BOGGABRI COAL MINE Rejection of Modification 8

We object to Boggabri Coal Modification 8. Herewith we submit our grounds for objection. The Modification proposes to add 6 years to the life of the mine and an additional 61.8 Million Tonnes per Annum of coal to be mined.

Table 1. Summary of data supplied in Mod 8 Appendix G

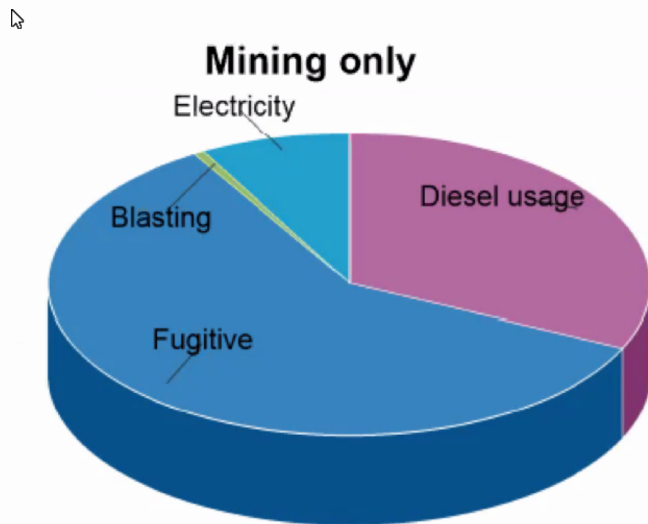
Table shows that carbon emissions are not going to be manageable.

Pie Chart shows Scope 1 emissions, which represents all onsite carbon emissions. With a pathetic strip ratio, as evidenced in the column graph, the cost of diesel usage is attributable to the cost of moving overburden rock around the site.

Table 2. Scope 3 emissions

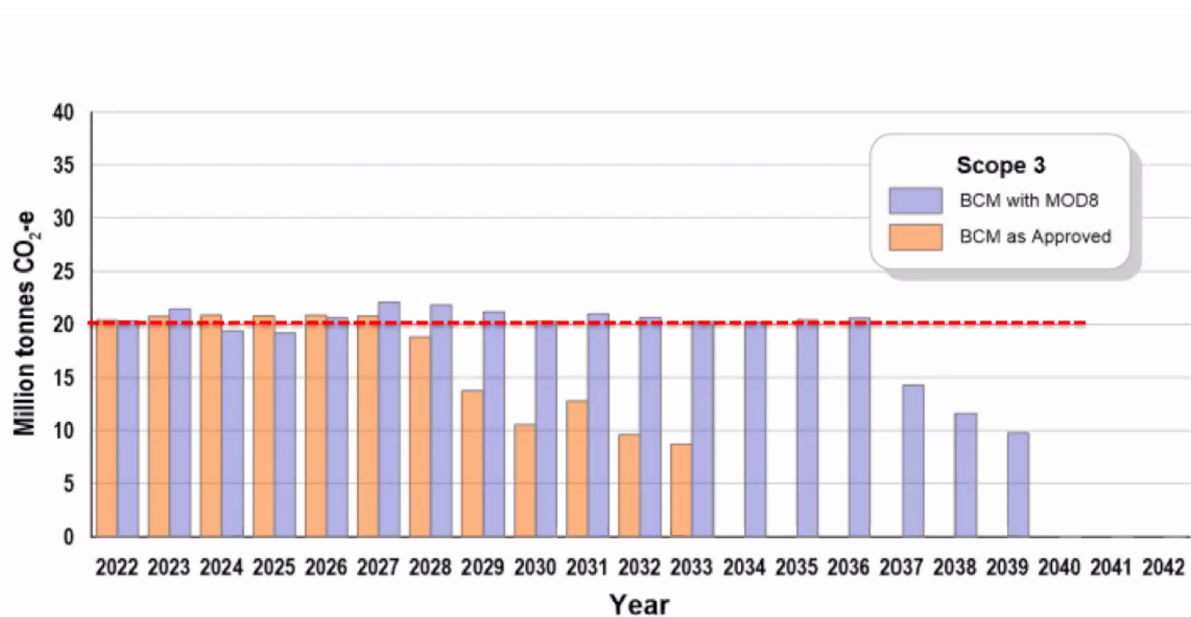
Here is some relevant data which illustrates clearly that Boggabri Mod 8 is a carbon bomb.

Below: Figure 13, Appendix G, Greenhouse Gas Assessment Report

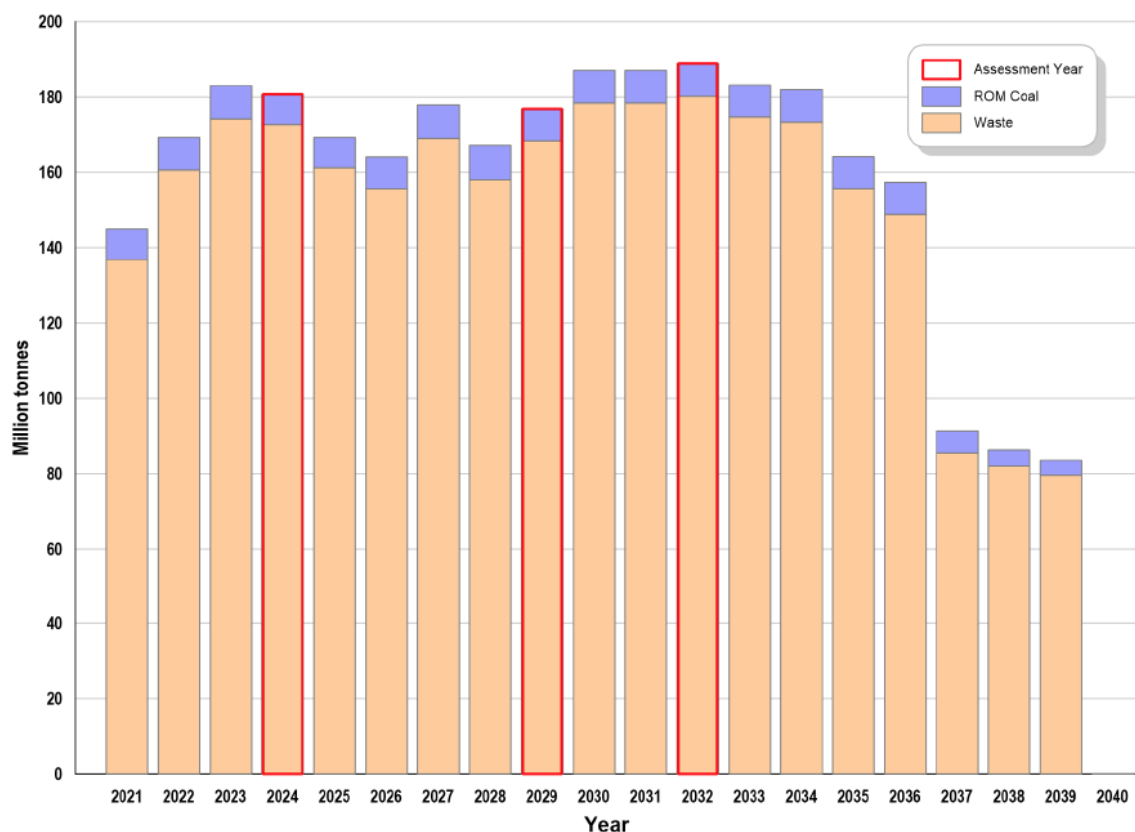
In Appendix G, the Mod 8 Greenhouse Gas Assessment Report includes a column graph showing the strip ratio from 2031 to 2039. The orange colour represents “waste”, by which is meant overburden rock which is needed to remove to get access to the coal seams. This represents an enormous amount of vehicle movements, all creating diesel emissions. This is a problem not only for GHG emissions but also particulate pollution which at times is already visibly severe (from our observations and photographic records).

It is hard to conceive that such a poor strip ratio has been submitted for consideration by the Department. This should be taken into account when the Department assesses the economic viability of Mod 8. Under economic viability we request that the Department has consideration for the cost of rehabilitation and safe closure of the mine and maintenance of the pit seepage into the future.

Figure 8.11 Porous rock take – approved mining vs MOD 8

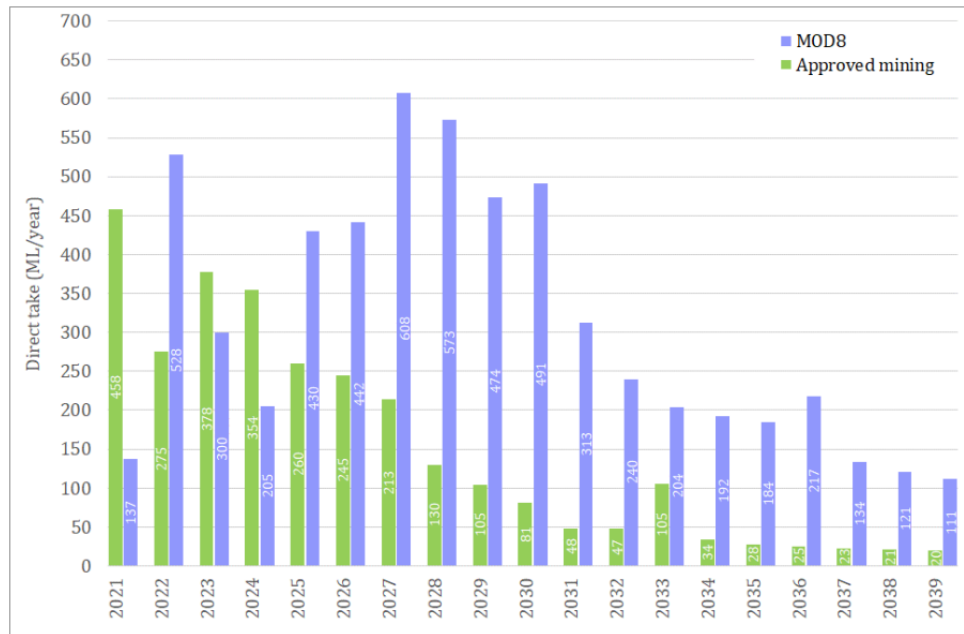
The largest percentage of water source in the highest year of maximum take (as shown in table below) is from the Gunnedah Oxley basin (the Porous Rock Groundwater Source). Not enough is known about the interconnections between the Alluviums, 4,5 and 11 and the Gunnedah Oxley basin, and there are multiple users who are helping themselves (or in the case of Santos Gas, planning to) with little to no understanding of the importance of the Porous Rock aquifer in maintaining pressure and the interrelationship with the alluvium. The table below shows the maximum annual takes for the Zones 4,5 11 and Porous Rock.

The Mod 8 predictions over the proposed Mod 8 lifetime are extremely revealing (see below).

Figure 8.12 Indirect take from zone 4 alluvium – approved mining vs MOD 8

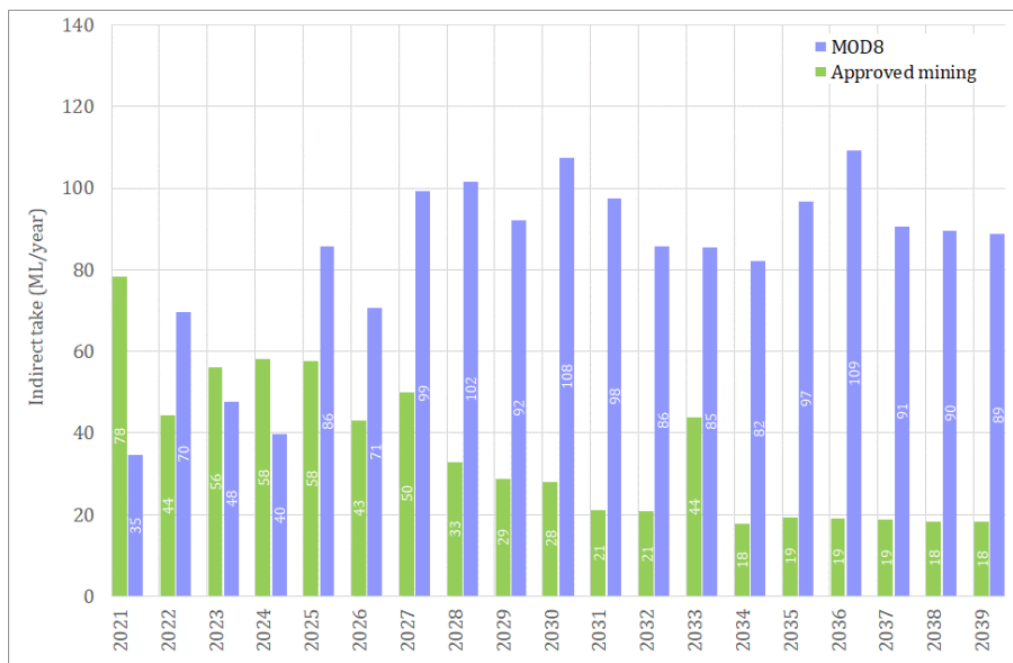
The groundwater assessment identifies that Modification 8 will cause more than 2m drawdown, up to a maximum of 5m in Zone 4 of the Namoi alluvium, a groundwater source which not only extends to the town of Boggabri but also is relied on by primary industry.

The assessment shows a significant escalation in the volume of annual take from Zone 4 of the alluvium as a result of this modification – in most years over 80ML per year and in some over 100ML. This impact extends to the Namoi River itself, with a predicted 2ML per year loss of baseflow. The assessment excuses this as a small volume in years and periods when the river is in flow. The Mod 8 trivialises the water loss.

Figure 8.13 Indirect take from zone 11 alluvium – approved mining vs MOD 8

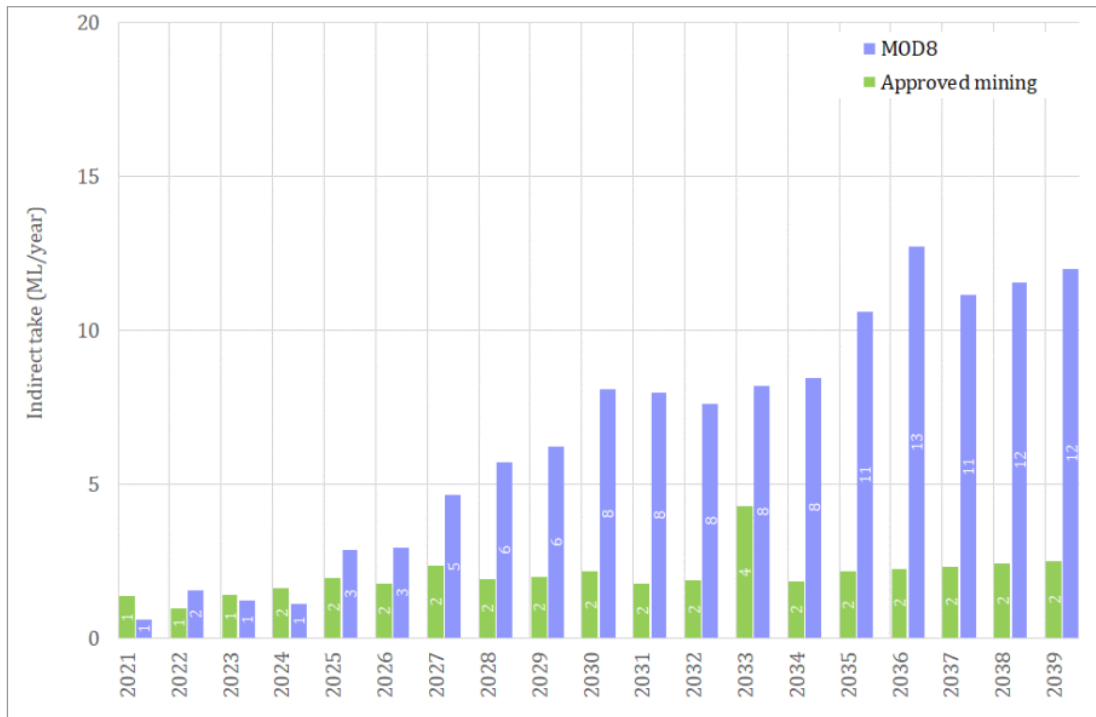
When we refer to the below figures we can see Zone 11 has the lowest take, but the largest increase on the existing take and will probably suffer the most damage because the existing entitlement is already so low. How can Boggabri Coal envisage increasing take from Zone 11 by such an extravagant degree.

Zone 11 is already in a critical state. The Department should not allow any project to take any more from Zone 11.

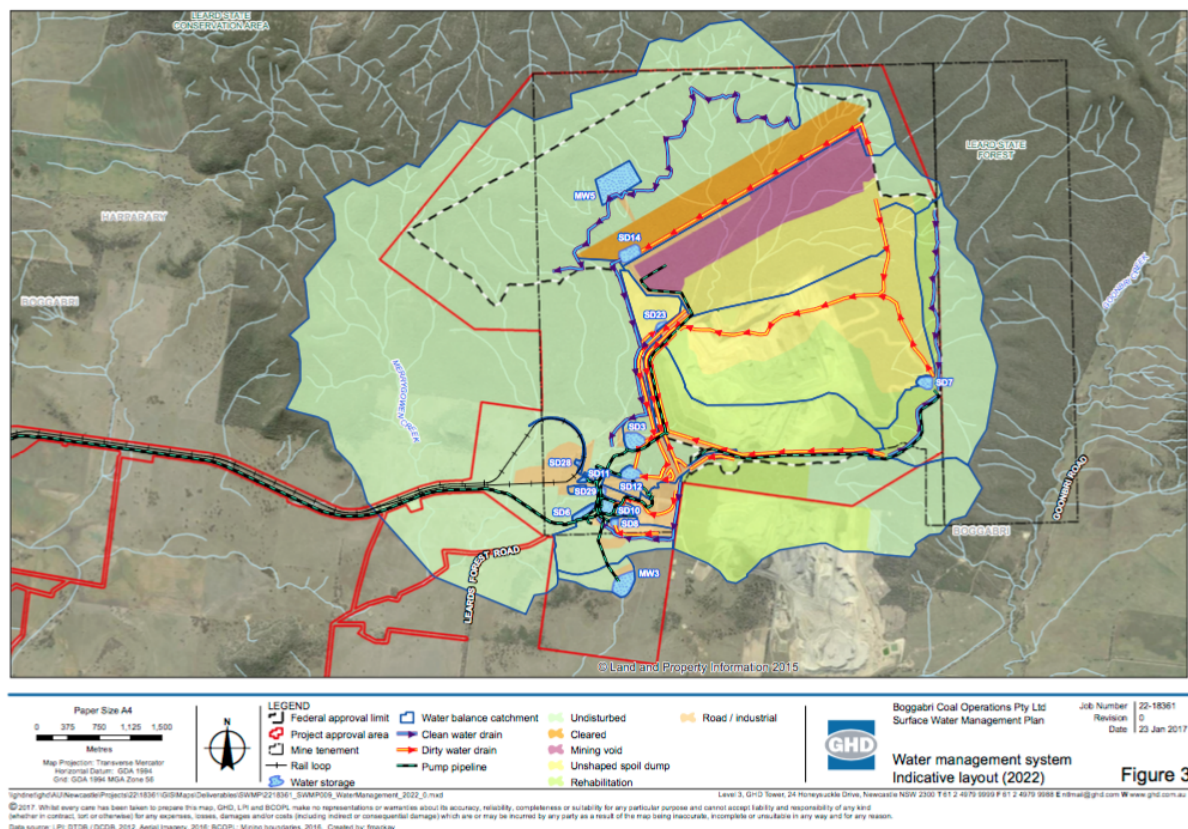
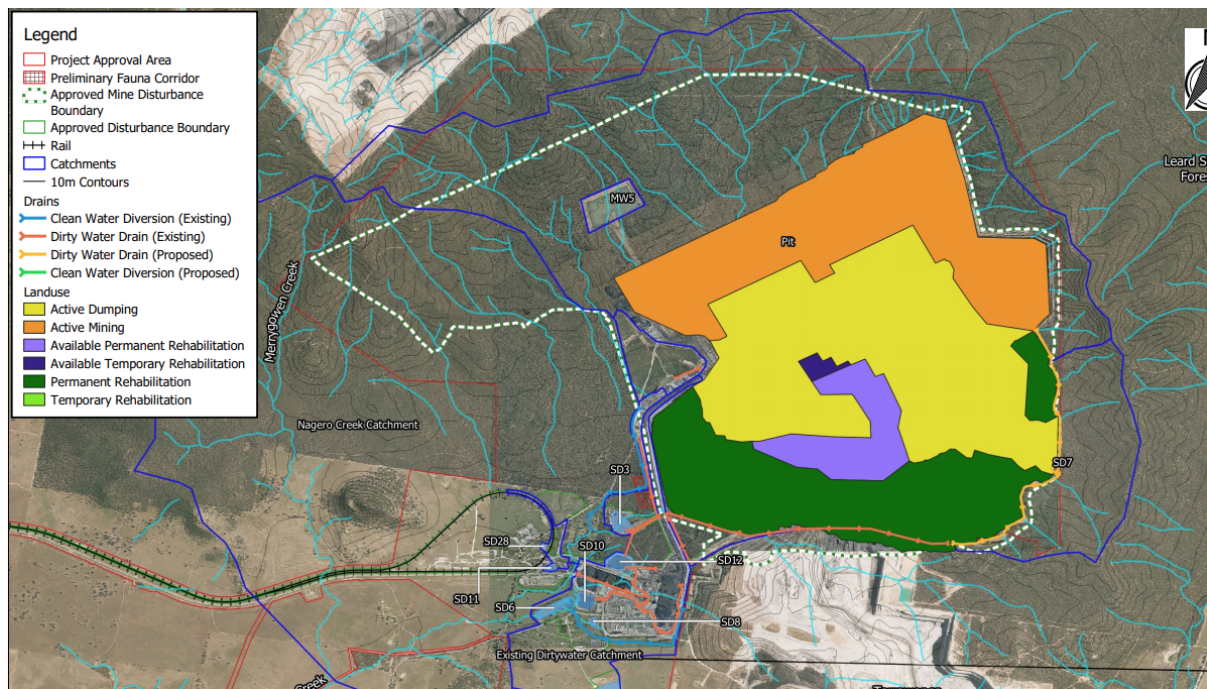
As we can see from the below figures (top figure, SWMP 2017 and bottom figure, from Mod 8) the systems for catching for surface water in Mod 8 are nowhere near as extensive as what appears in Boggabri’s approved Surface Water Management Plan (2017). However, we understand the SWMP is up for review. At no time should Boggabri Coal allow any surface water from the catchment to flow into any of the mine operating areas or be used by the mine.

Extreme care should be taken to ensure that all surface water is directed around the mine to Nagero Creek and to make its way there. We are particularly perturbed that in Mod 8 there are no drainage lines or high wall dams covering the catchment north and north west of the disturbed area.

Maps included in Mod 8 show Nagero Creek, a fifth order stream, and other streams, apparently flowing directly into the mine pit from the north and north west with no diversion works in place, contrary to the mine's 2010 Environmental Assessment.
